Product / Process Change Notification (PCN)

PCN Number: PCN_ConPSHD_20241213

Affected Series: WR-PSHD

Cosmetic changes on the housing

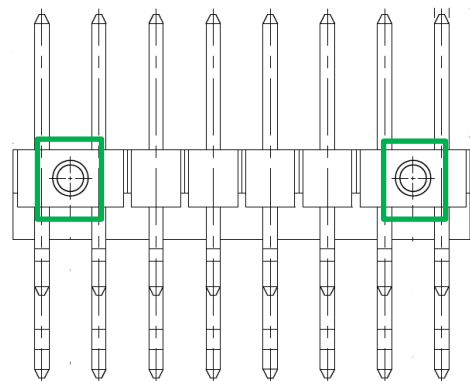
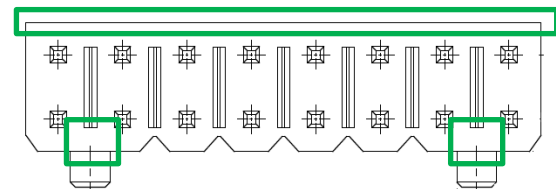
Due to an improvement of the production capability, Würth Elektronik eiSos will change the injection mold of the plastic housing. This implies a few cosmetic changes on the housing. Packaging specifications for 610106249121 will also be updated.

BEFORE CHANGE

AFTER CHANGE

For 610106249121:

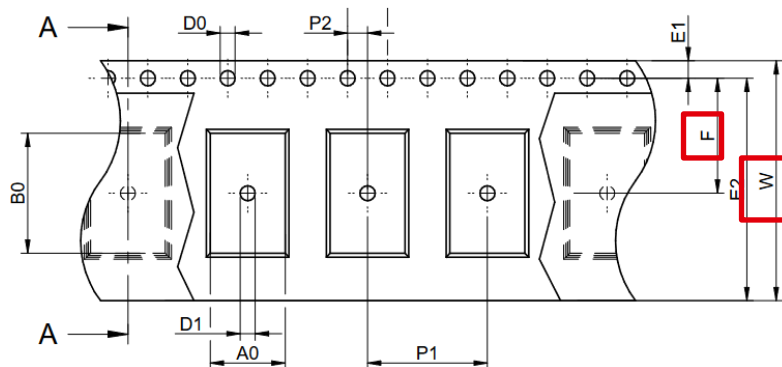
W (mm)	F (mm)	Parts / reel (SPQ)	Quantity / carton
BEFORE CHANGE	24	11.5	9	3150
AFTER CHANGE	16	7.5	12	4200
